August 9, 2019

RE: Adequacy Review 1 for 112 Construction Materials Reclamation Amendment 1 to the Permit, Bernhardt Gravel Mine, Permit M-2002-120; Response

This letter is being generated to satisfy the preliminary review dated June 4, 2019 for the Bernhardt Gravel Mine. The italicized items are the current comment and the bold text are the responses:

RECLAMATION
PLAN

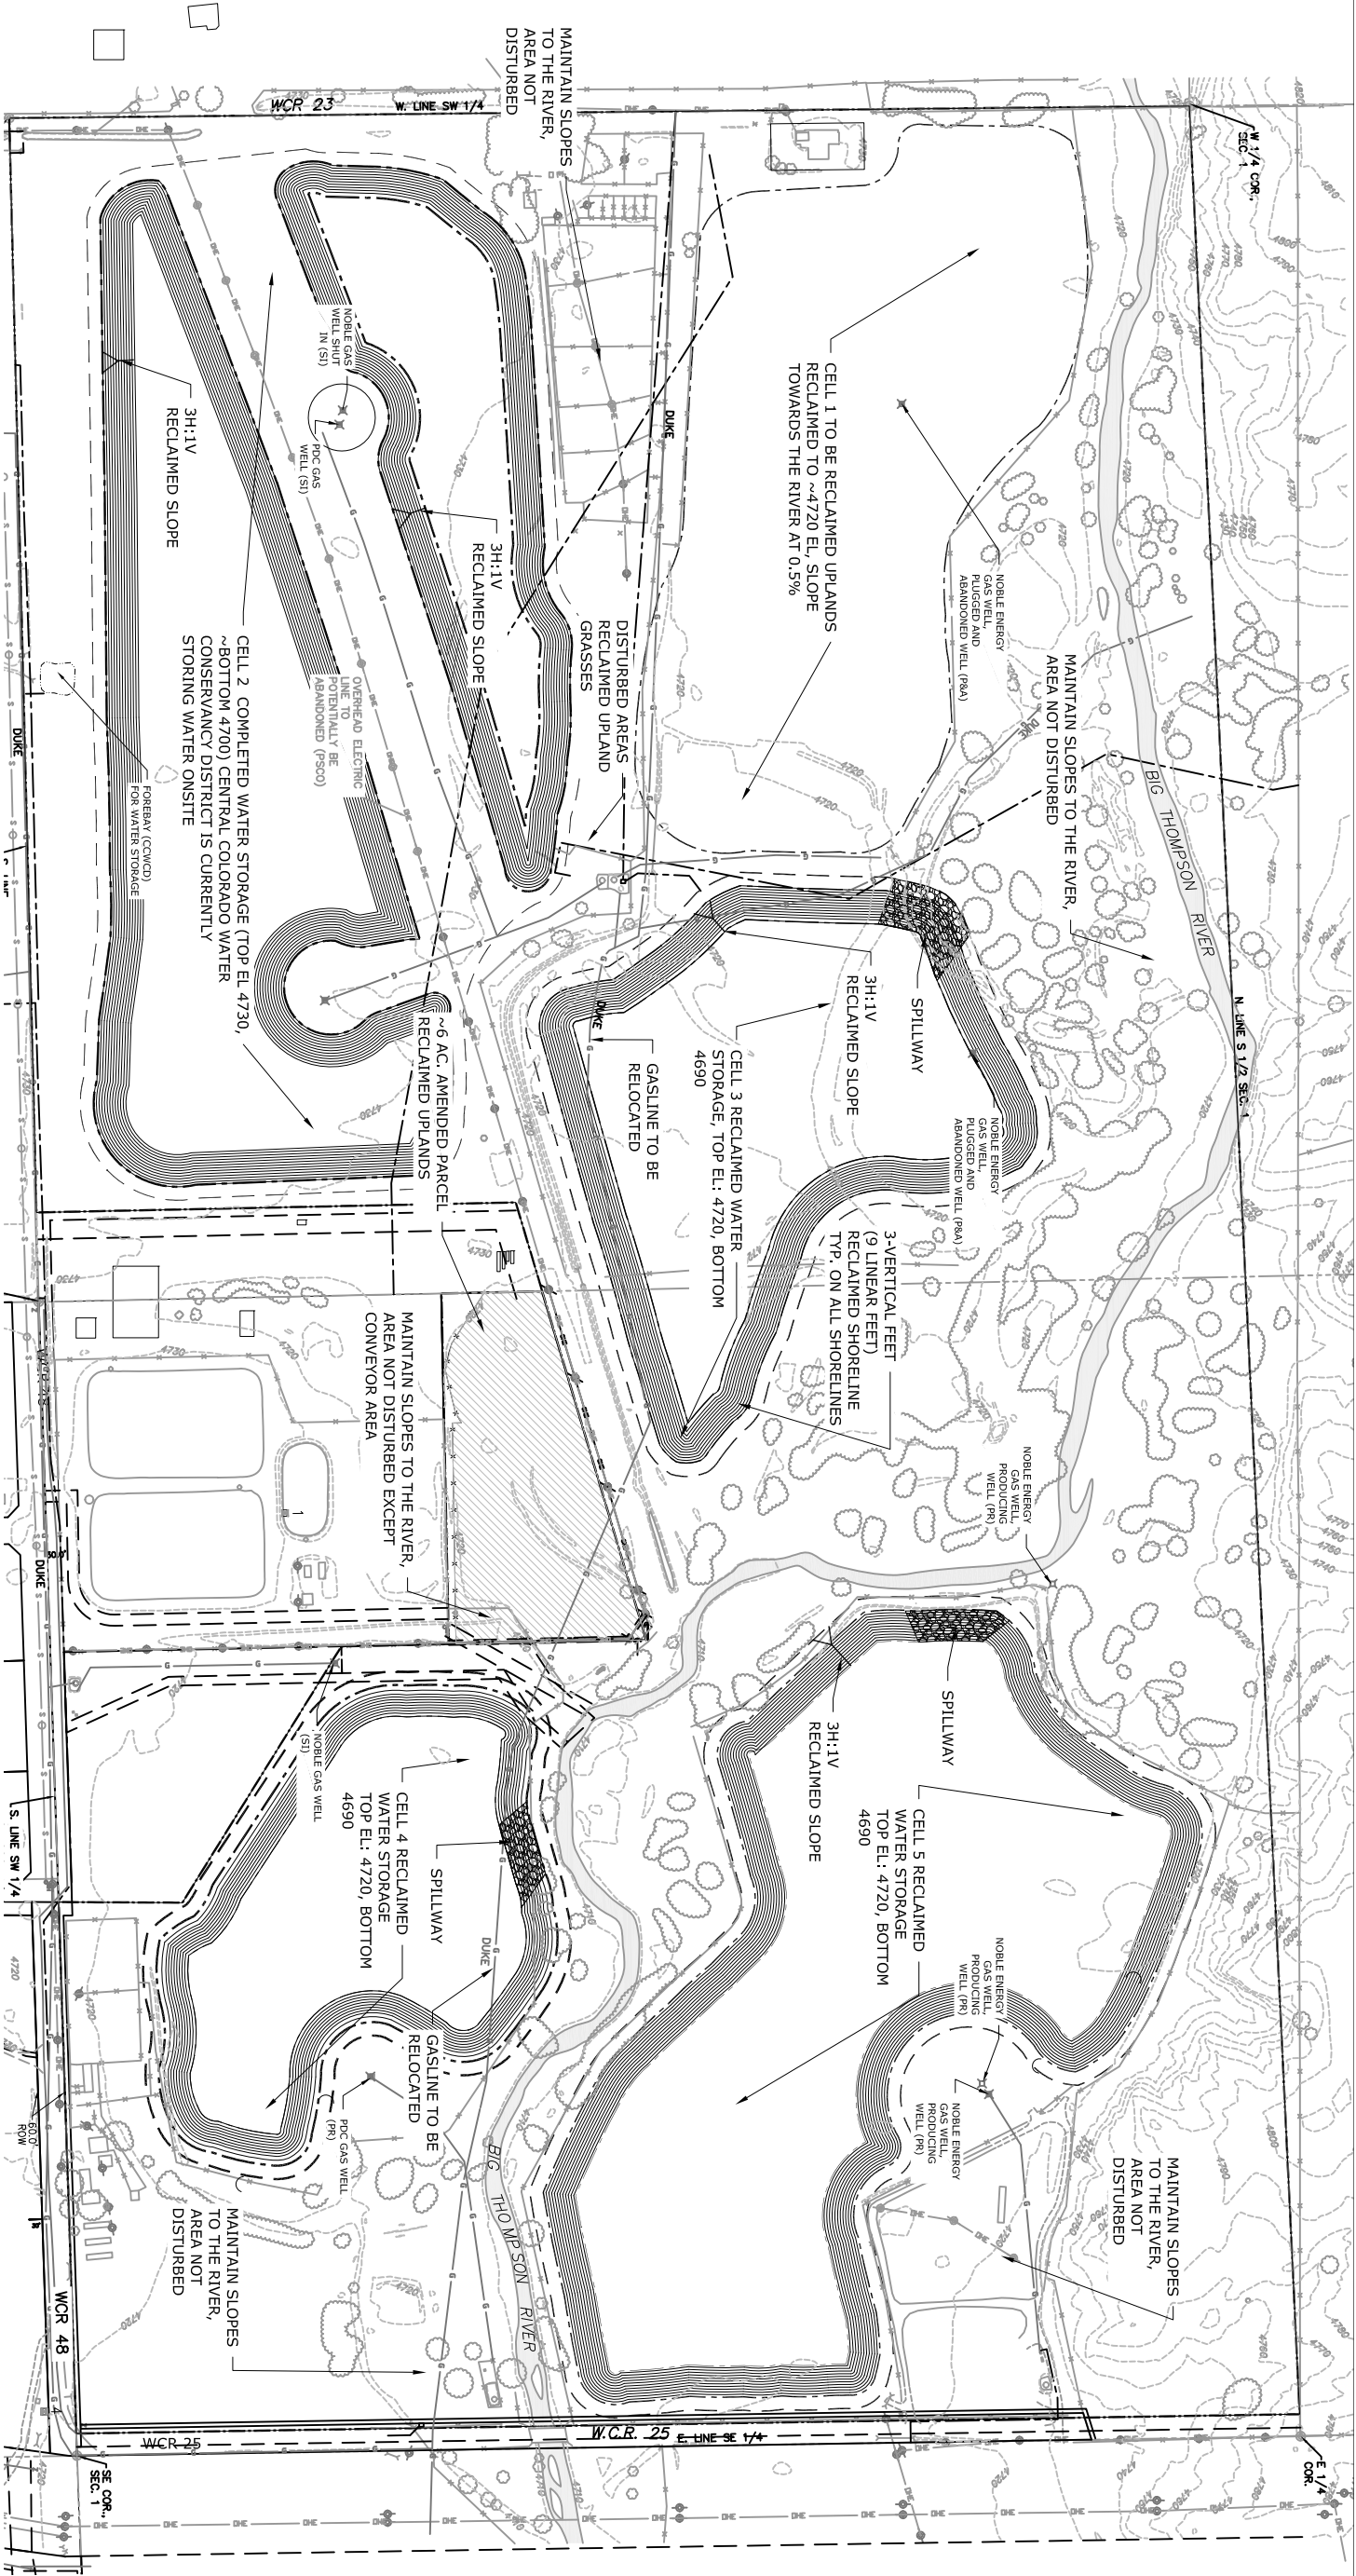
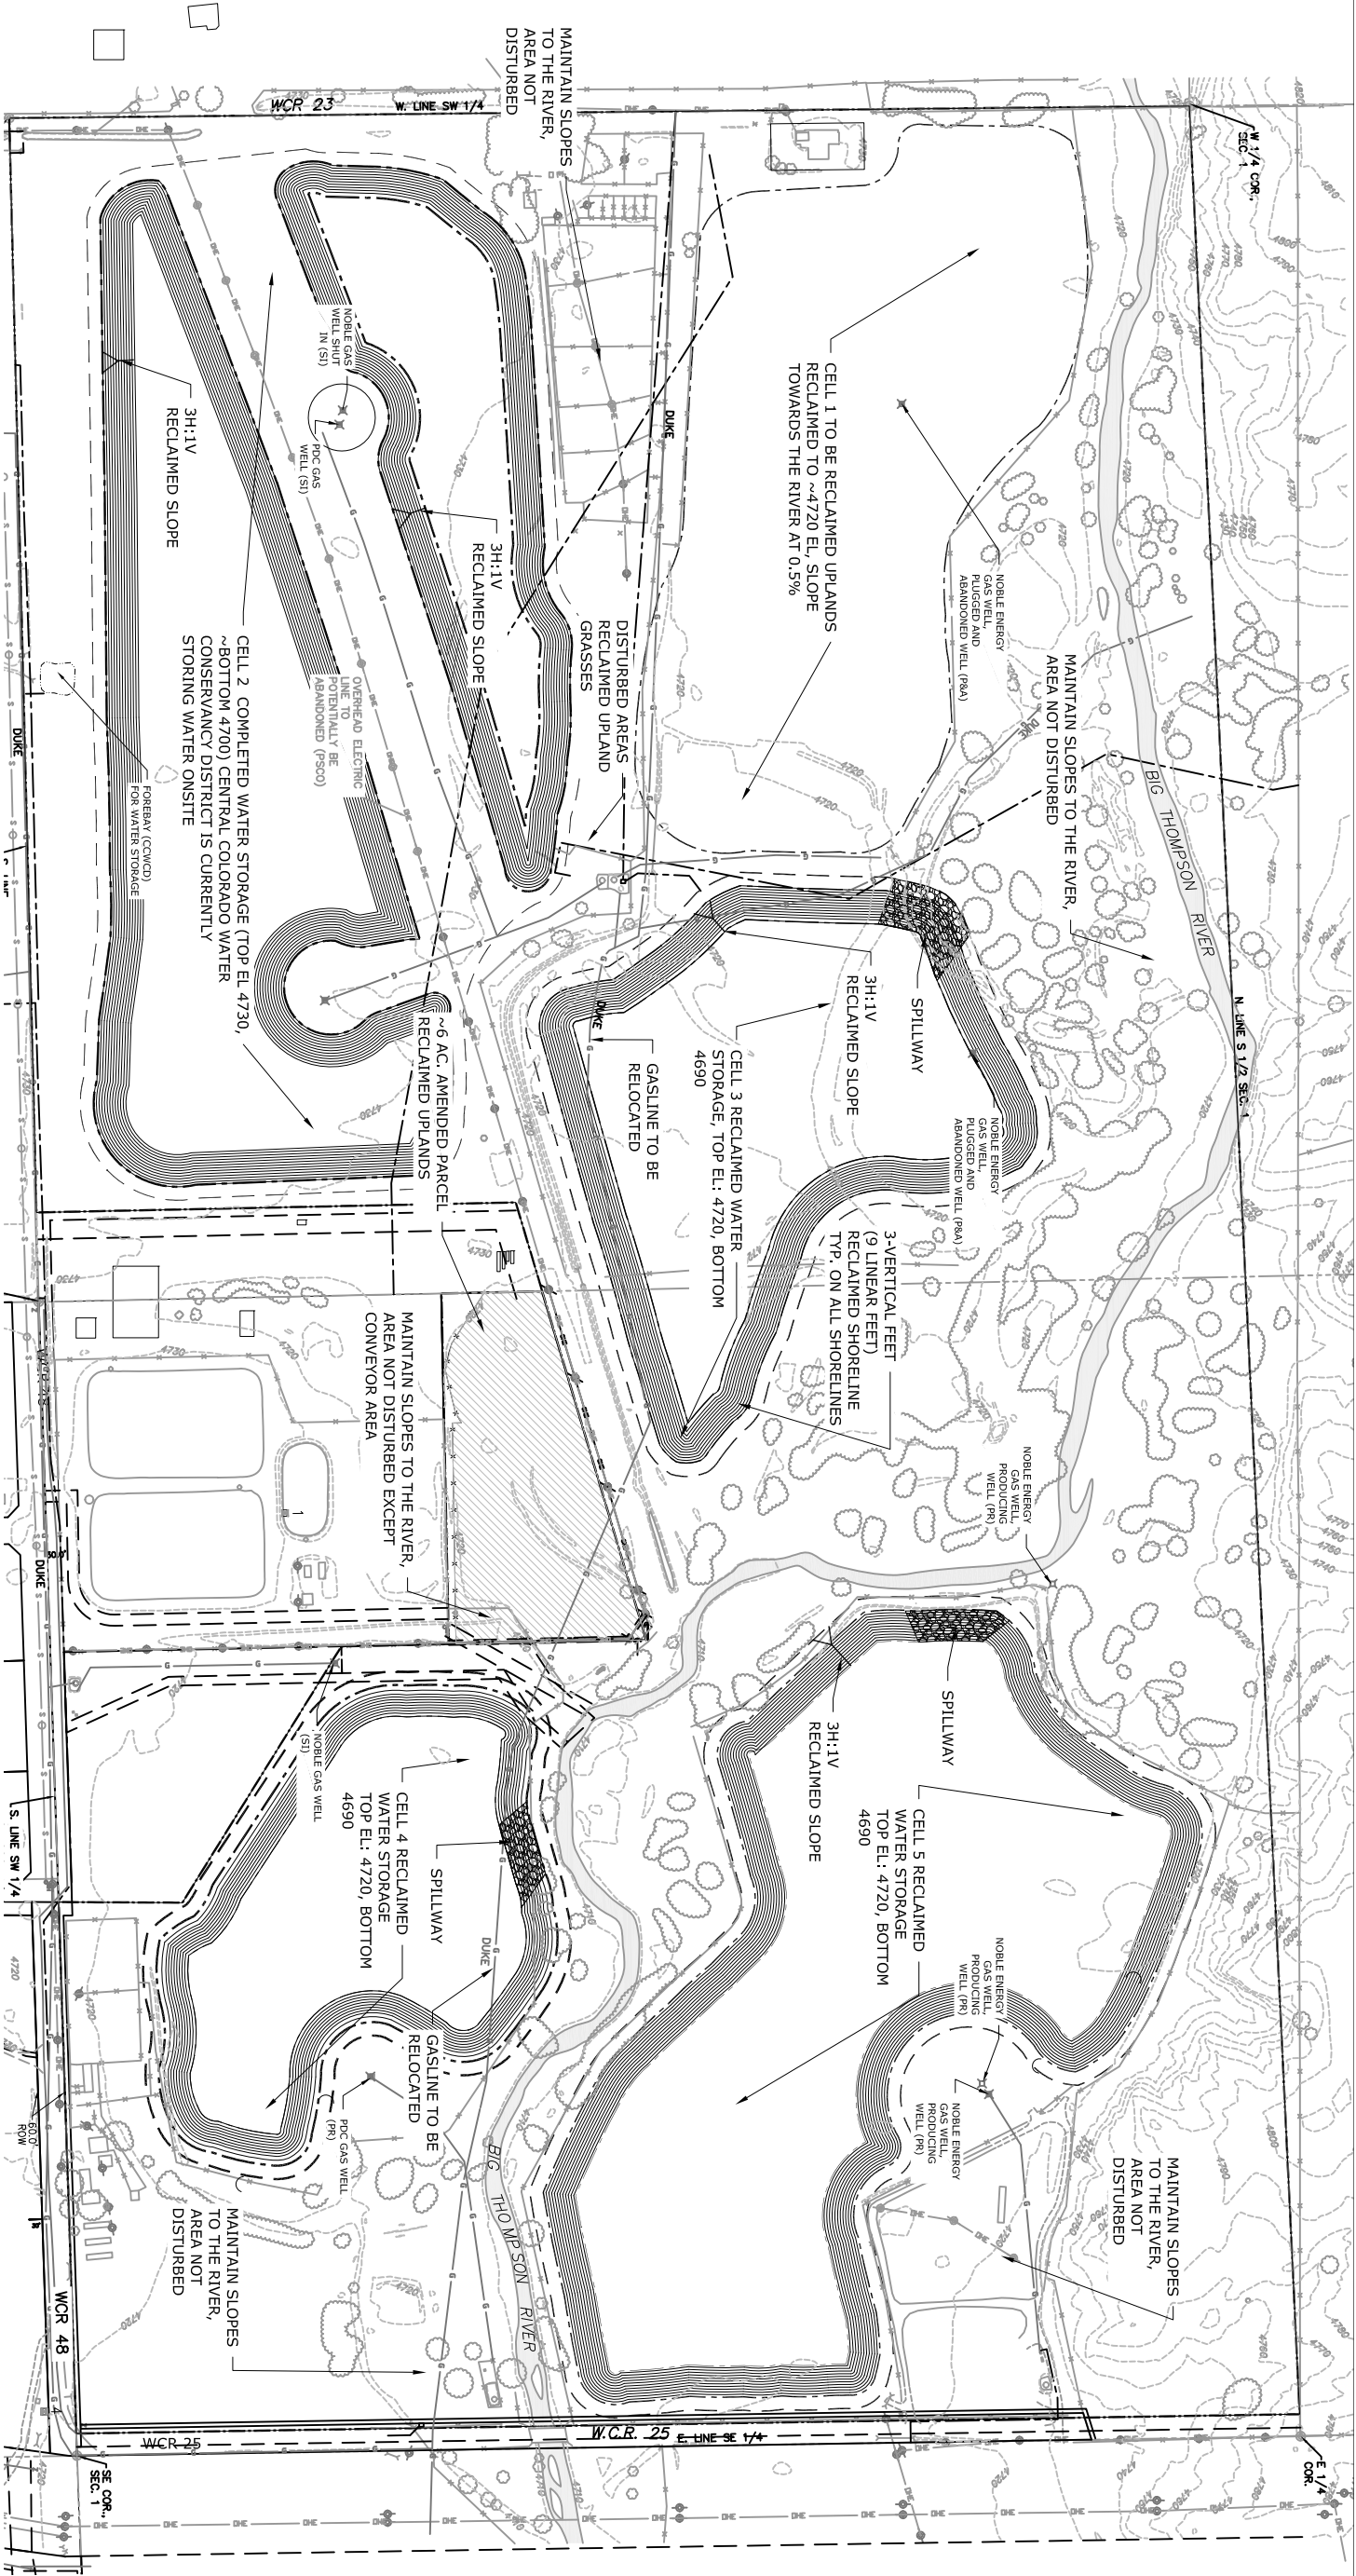
*Please revise reclamation plan map so that scale and north arrow are not obscured. **This has been updated.***

Cell 2 is stated as being "mined out" in the text and on the provided map, but the existing configuration does not match the reclamation plan map. Please revise reclamation plan and map to show the proposed final configuration of Cell 2 when mining is complete (open water vs. upland). Cell 2 is reclaimed water storage and the areas shown on the reclamation plan show the area that will remain upland.

There is a phase "5A" shown on the reclamation plan map, but it is not addressed in the reclamation plan – please revise as necessary. 5a is incorrect and should all be referred to as 5.

Please revise reclamation plan map for readability as previously described in the comments for Rule 6.2 and Exhibit C. Define area "5A" or remove from map.

Reclamation map should show contours of proposed final reclamation topography, not pre-mining topography.

Please revise reclamation plan map to show structures remaining within the permit area when mining and reclamation is complete. Features not remaining within the permitted area when reclamation is complete (topsoil stockpiles, conveyors, relocated utilities, etc.) should be removed from the map.

Reclamation plan map should show areas of proposed upland reclamation, shoreline area, final shoreline/open water configuration, undisturbed areas, locations of existing and proposed slurry walls, and locations of flood control inlet/outlet structures.

The amended area will not be mined and will only be used as a location for the conveyor to cross. The remainder of the site will be mined as discussed in this response and shown on the plans/maps. **An updated reclamation plan has been included in this response.**
